91-23

## A. USE OF PRIORITY VALVE KIT FOR DUAL POWER STEERING ON 3.0 L AND 3.0 LX

3.0L/3.0LX Style Pump

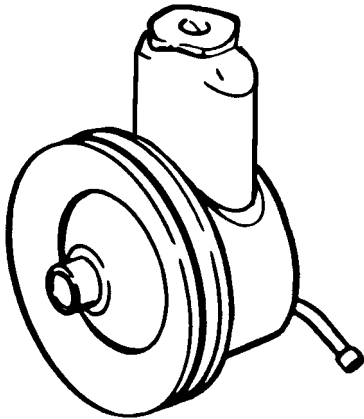
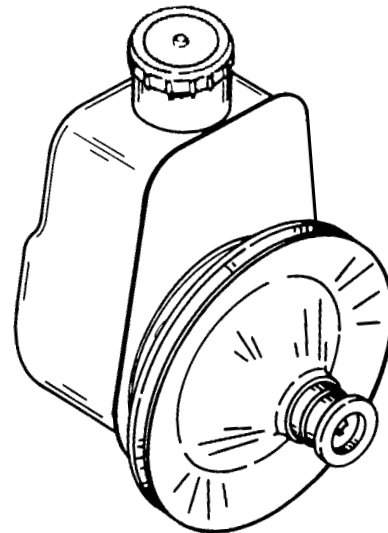
The priority valve kit **WILL NOT WORK ON THE 3.0L OR THE 3.0LX** engine due to the new cover assembly. The cover was designed for use on the newer style pump that is used on the V-6 and V-8 engines.

The pump on those engines has a straight neck which allows the cap O-ring to seal on the side of the neck and to help stabilize the cap to prevent any oil leakage from the cover tilting to one side. Because of the added inside dimensional changes the cap will not work on the 3.0L and 3.0LX style pumps because the cap has too long of a side skirt on it to latch down on to the pump. It is not recommended nor is it acceptable to alter the cap in any way, fashion or form to make it fit because it will leak and could cause a loss of fluid and cause hard steering.
